**ADDENDUM TO THE CONTRACT**  
**for the**  
**PORTAGE COVE HARBOR EXPANSION**

**ADDENDUM NO.: TWO**

**DATE ADDENDUM ISSUED:** September 29, 2016

SHEET TITLE: **WASTEWATER OUTFALL PLAN & PROFILE**

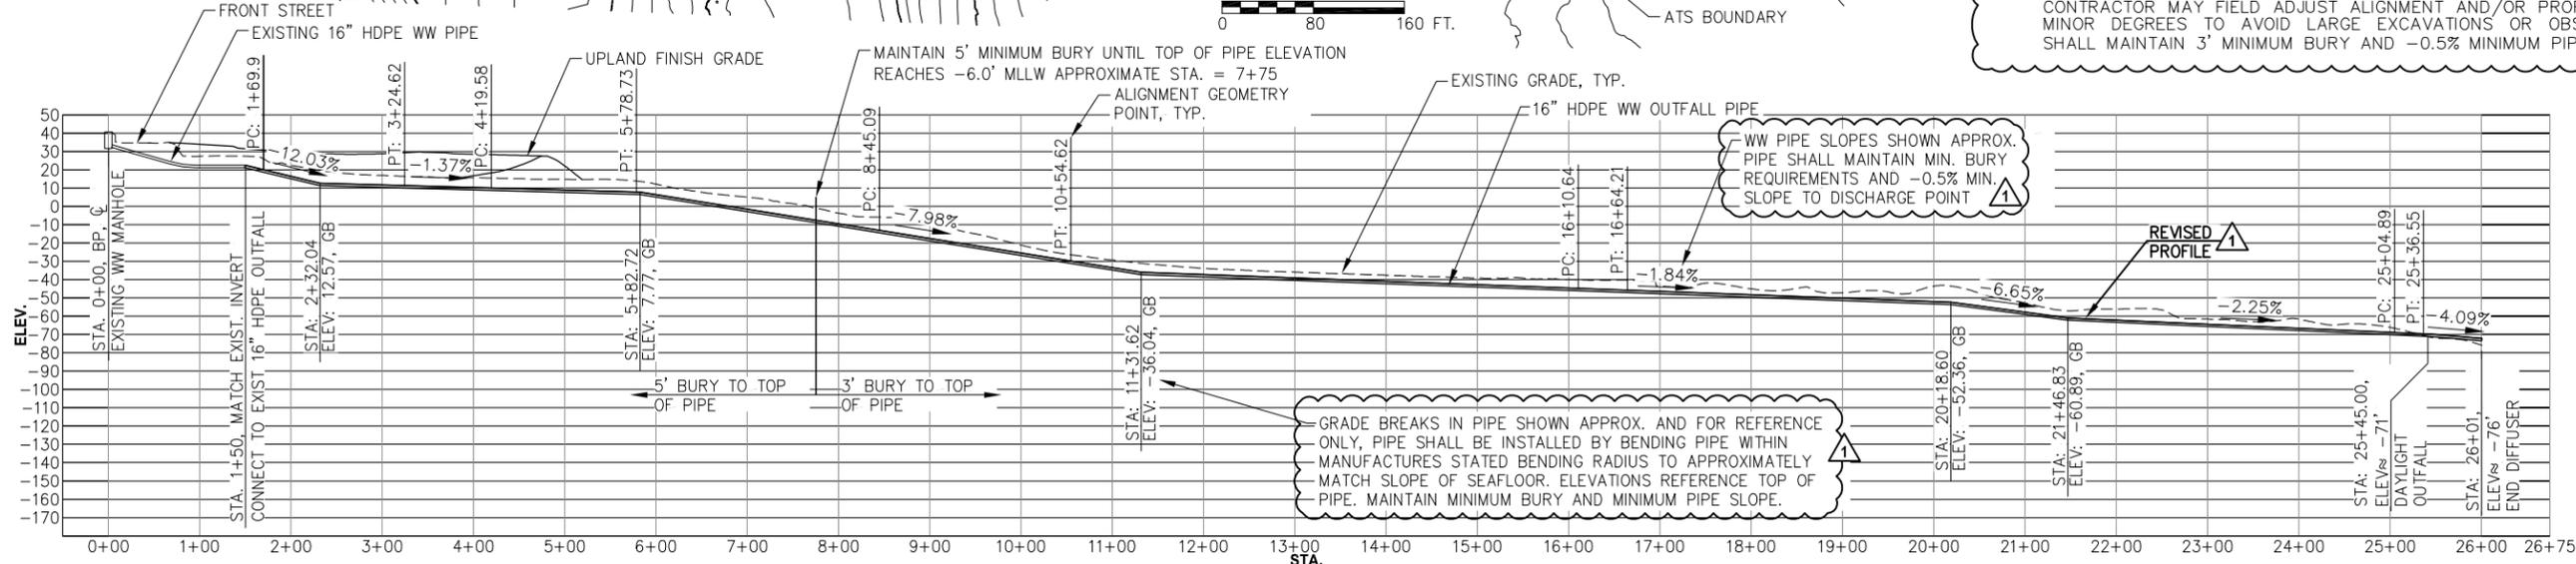
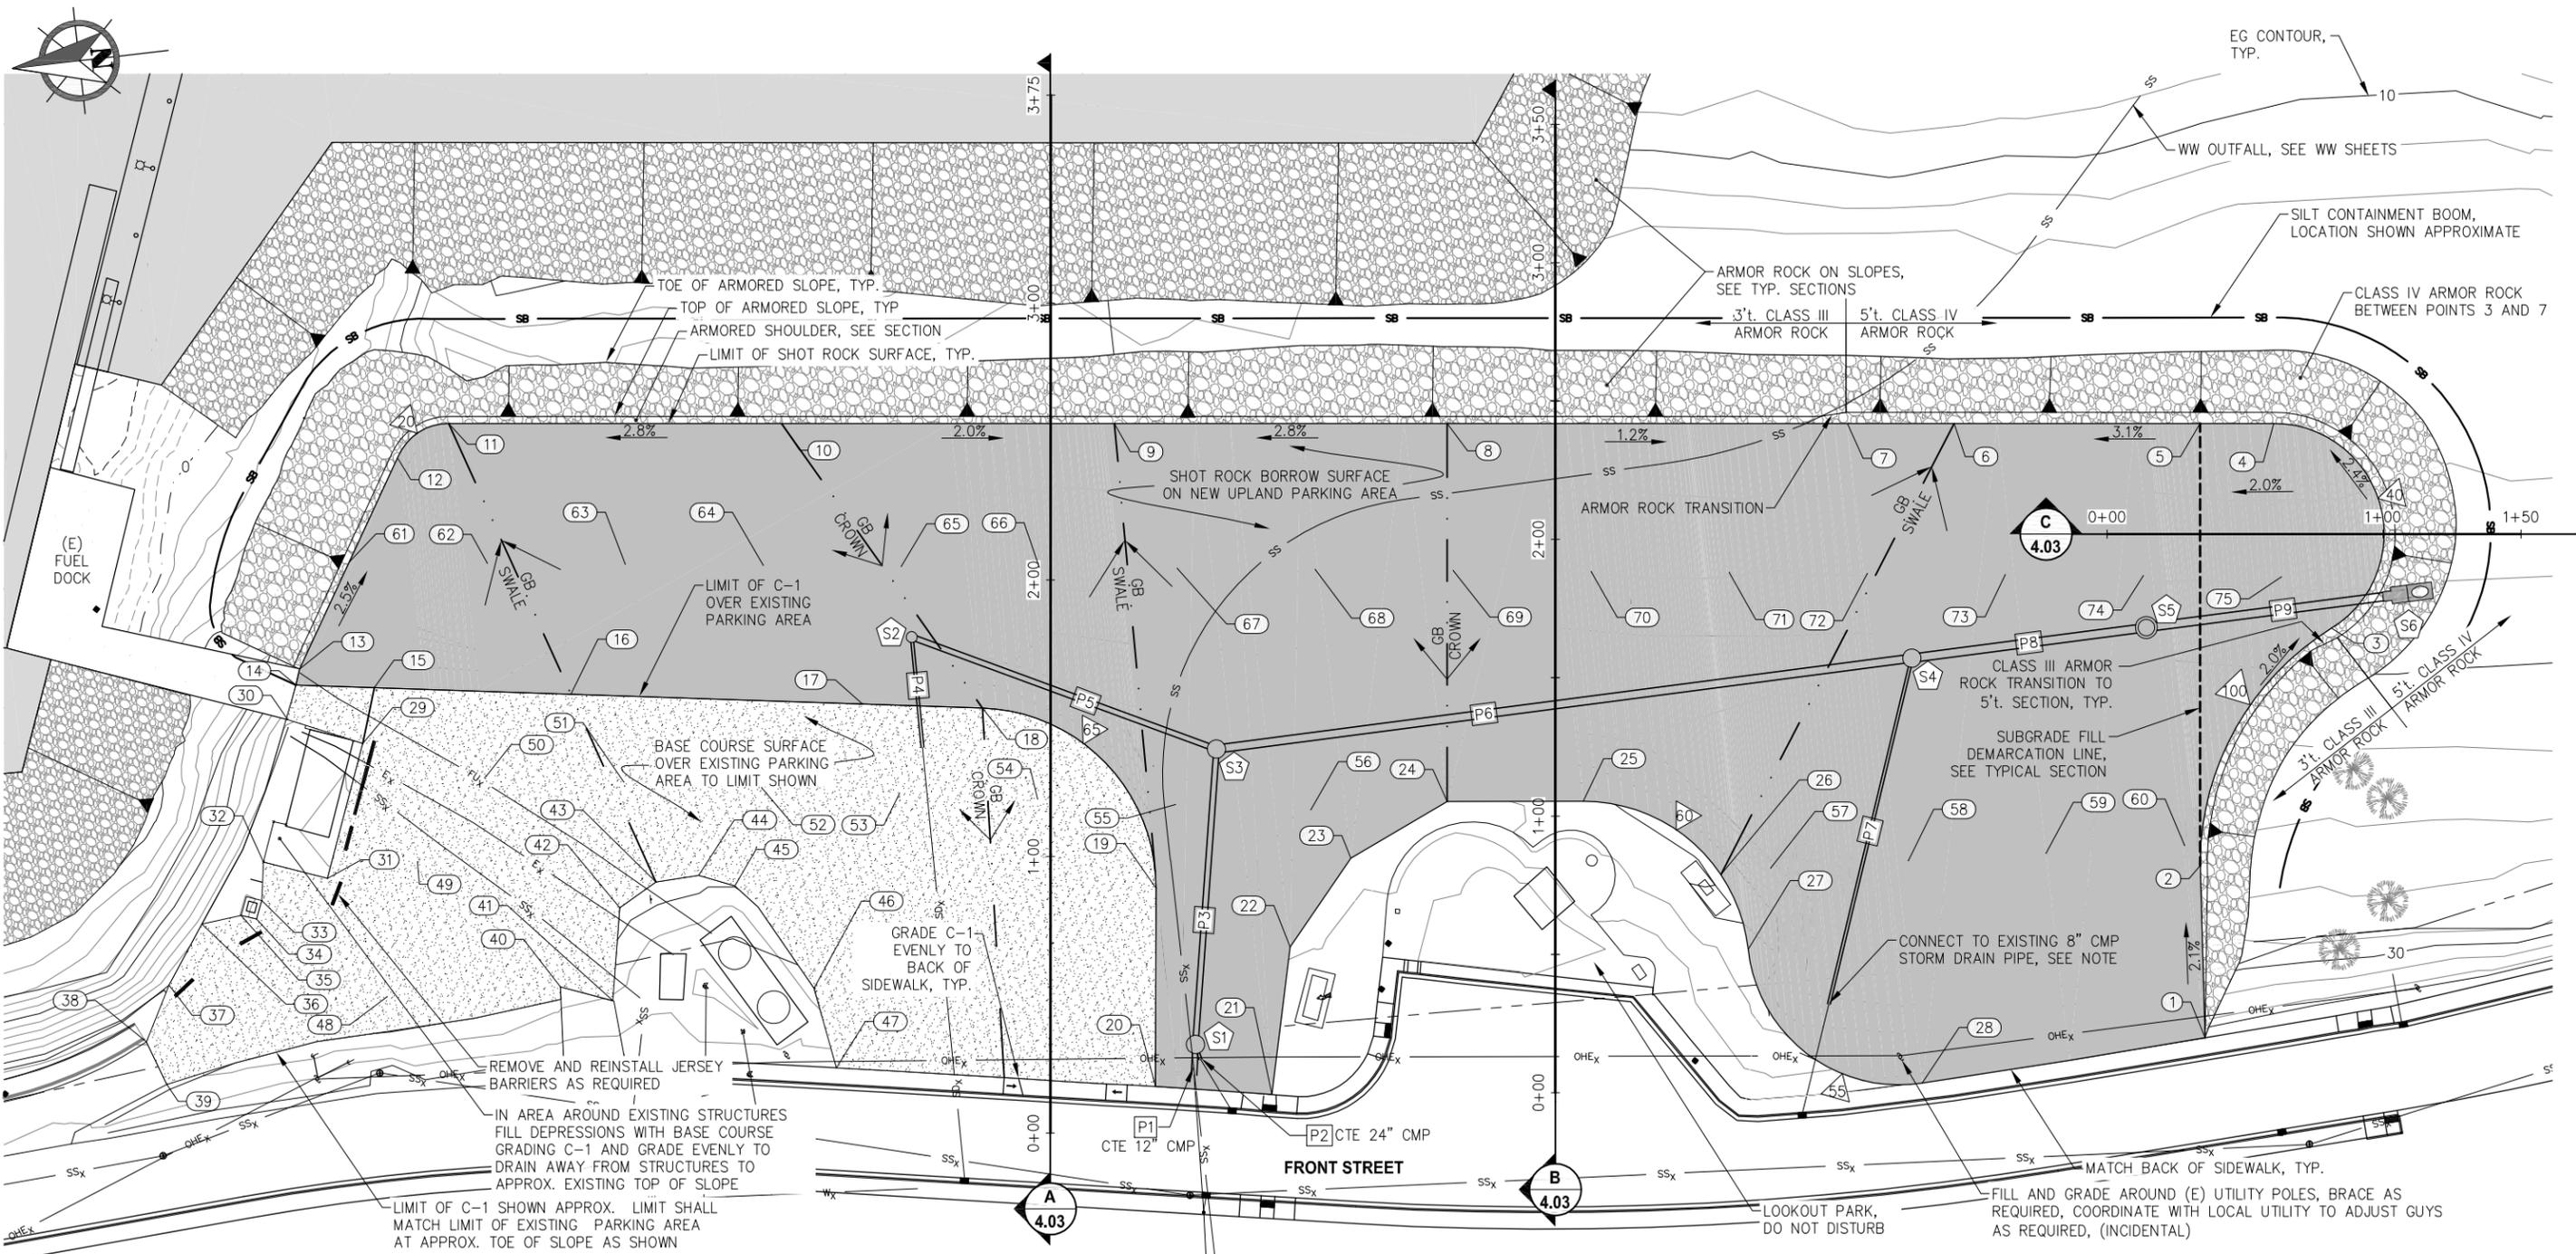
**Item No. 20** DRAWING SHEET 2.01 WASTEWATER OUTFALL PLAN & PROFILE: *Replace* drawing in its entirety with the attached drawing similarly titled, labeled Addendum No. 2 and dated 9/21/16.

REVISIONS					
REV.	DATE	DESCRIPTION	DWN.	CKD.	APP.
1	9/21/16	ADDENDUM NO.2: ALIGNMENT AND PROFILE MODIFICATIONS	TCB	CRS	CRS

SHEET TITLE: **UPLAND GRADING AND DRAINAGE PLAN**

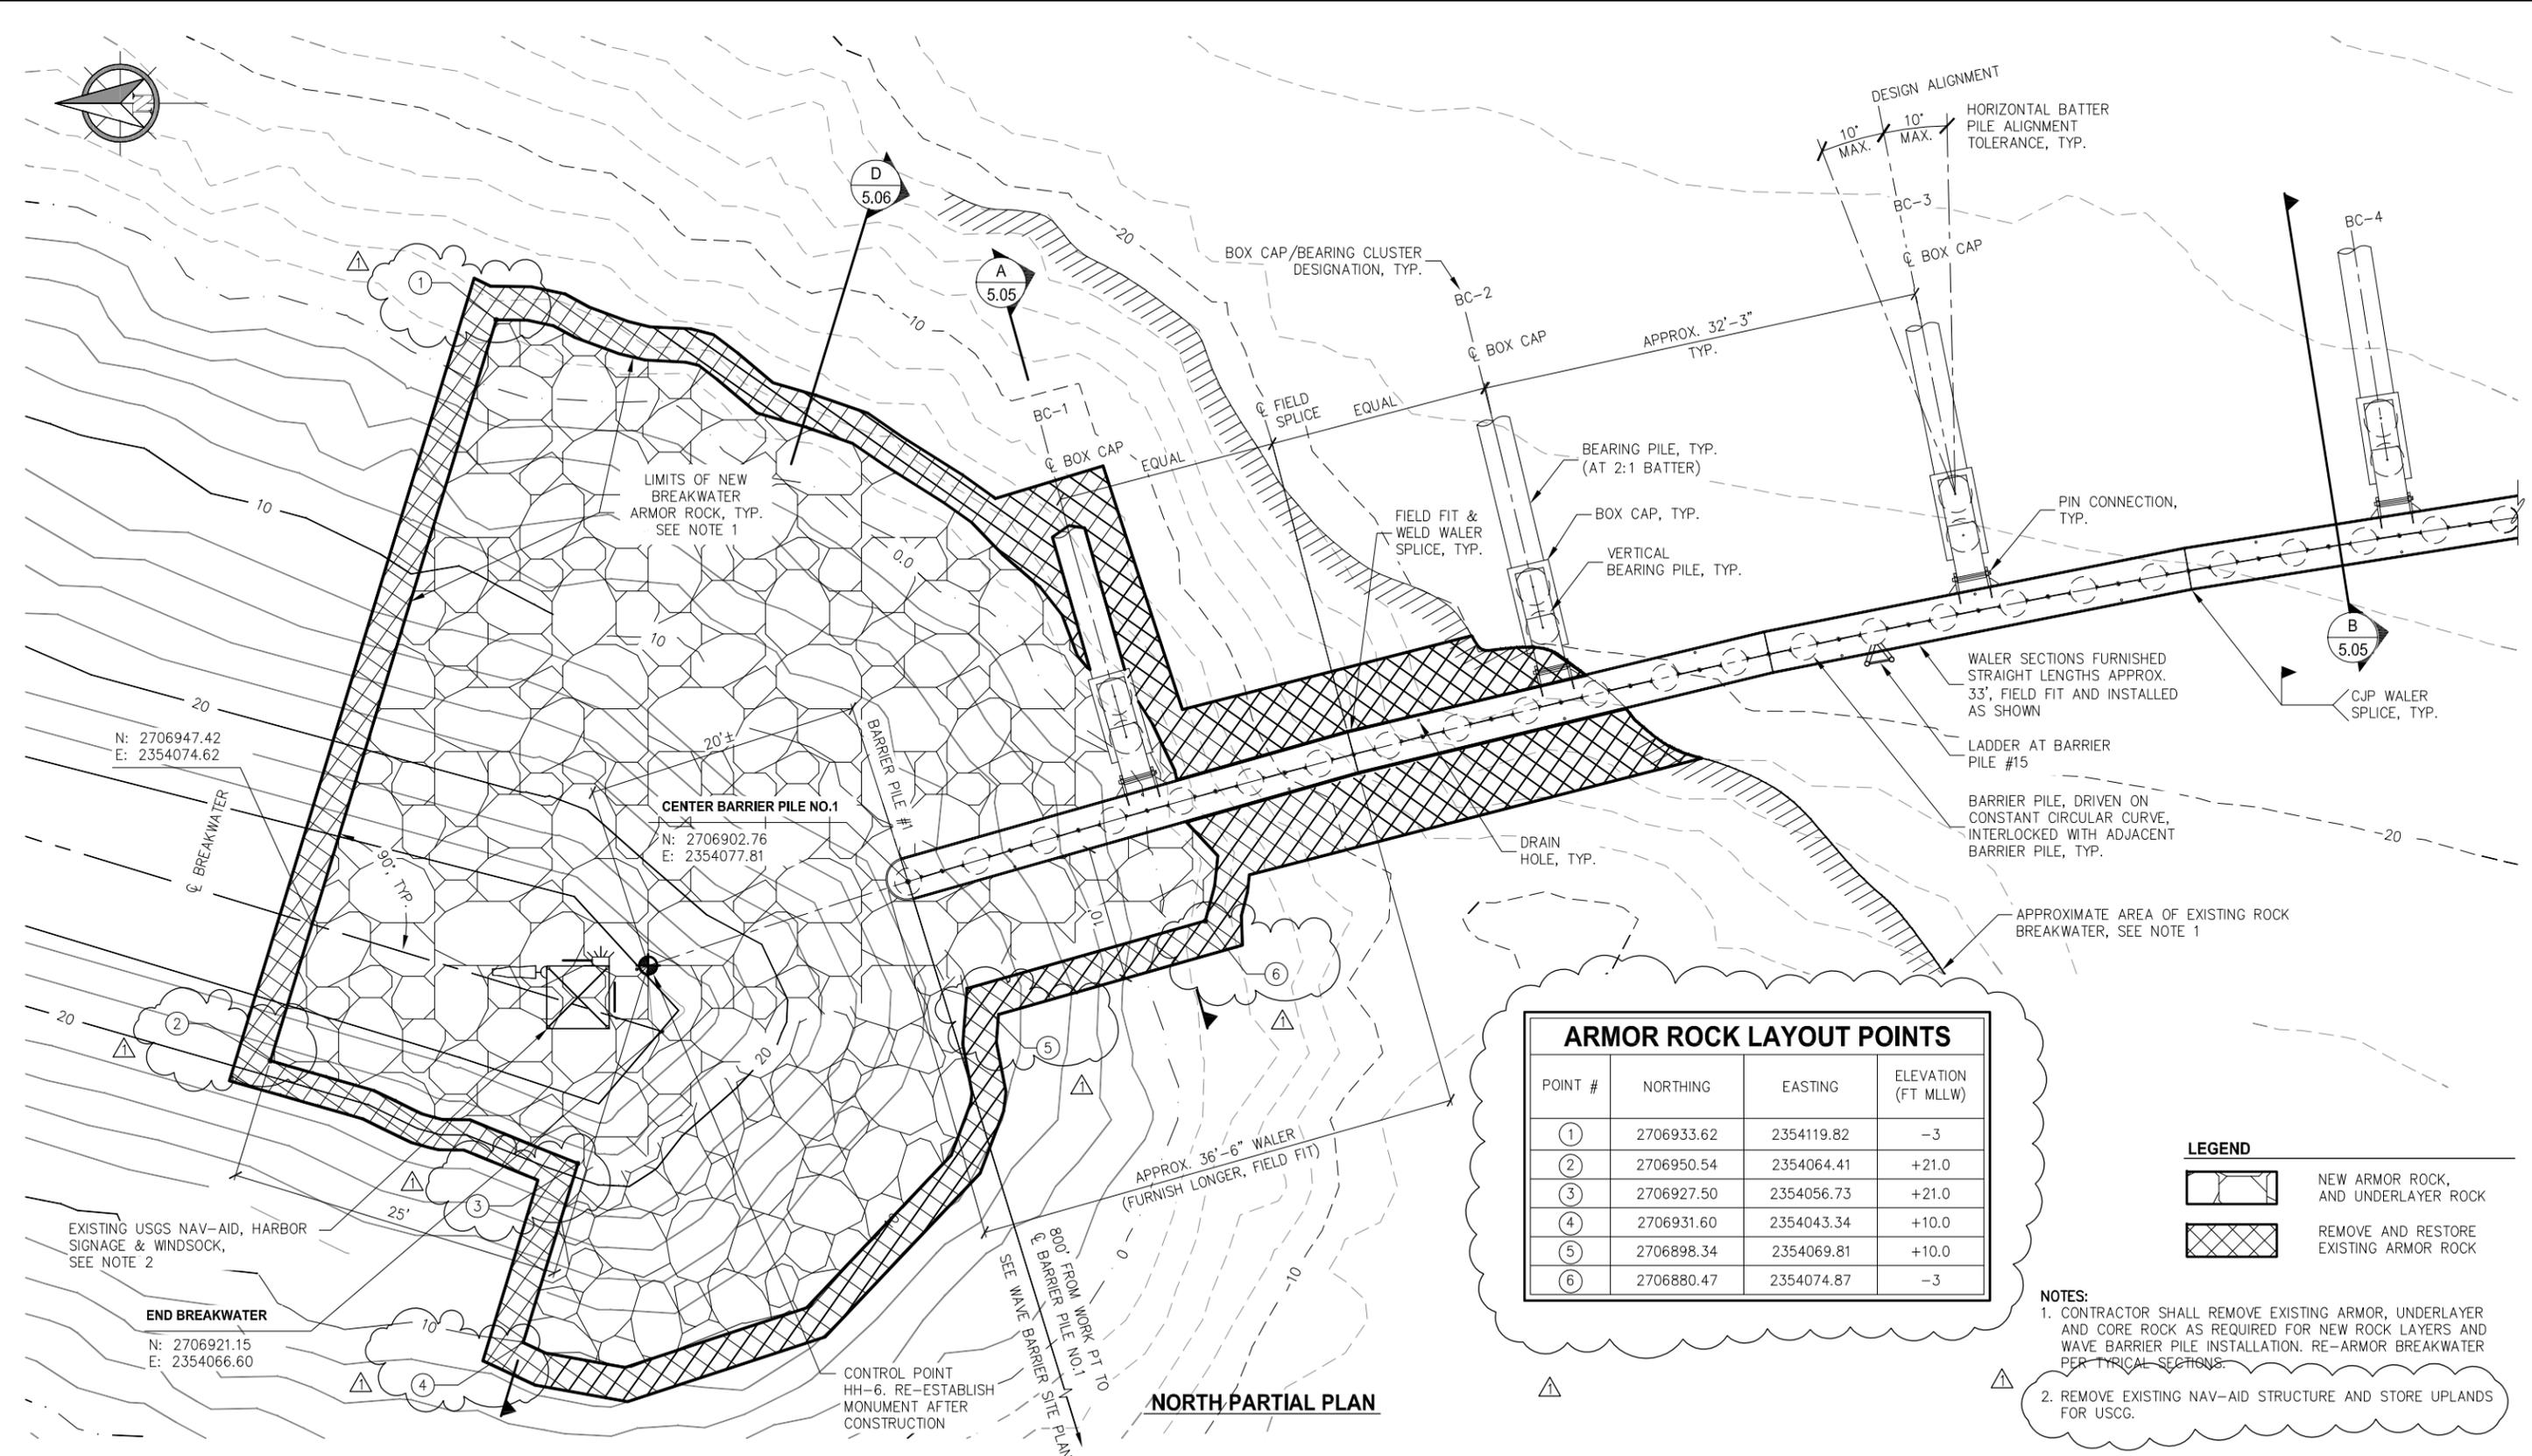
- Item No. 24** DRAWING SHEET 4.02 UPLAND GRADING AND DRAINAGE PLAN: *Replace* drawing in its entirety with the attached drawing similarly titled, labeled Addendum No. 2 and dated 9/21/16.

REVISIONS					
REV.	DATE	DESCRIPTION	DWN.	CKD.	APP.
△	9/21/16	ADDENDUM NO.2: LAYOUT POINTS SHOWN	TCB	CRS	CRS

SHEET TITLE:  
**WAVE BARRIER NORTH  
PARTIAL PLAN**

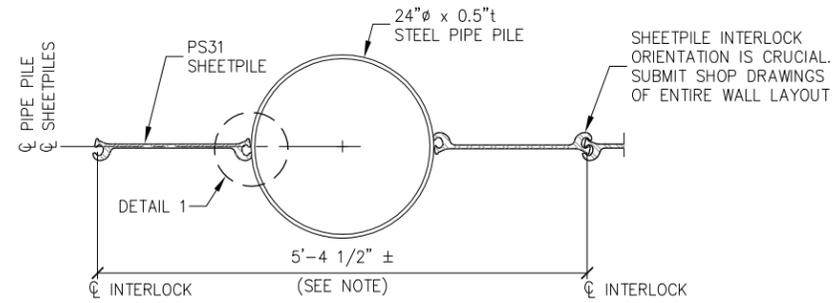
- Top slab shall be required for Manhole S2 only, reducing cone or top slab may be installed elsewhere.
- Item No. 27** DRAWING SHEET 5.02 WAVE BARRIER NORTH PARTIAL PLAN: *Replace* drawing in its entirety with the attached drawing similarly titled, labeled Addendum No. 2 and dated 9/21/16.

REVISIONS					
REV.	DATE	DESCRIPTION	DWN.	CKD.	APP.
Δ	9/21/16	ADDENDUM NO.2: ARMOR ROCK LAYOUT POINTS, AND NOTE.	PJD	JDO	CRS
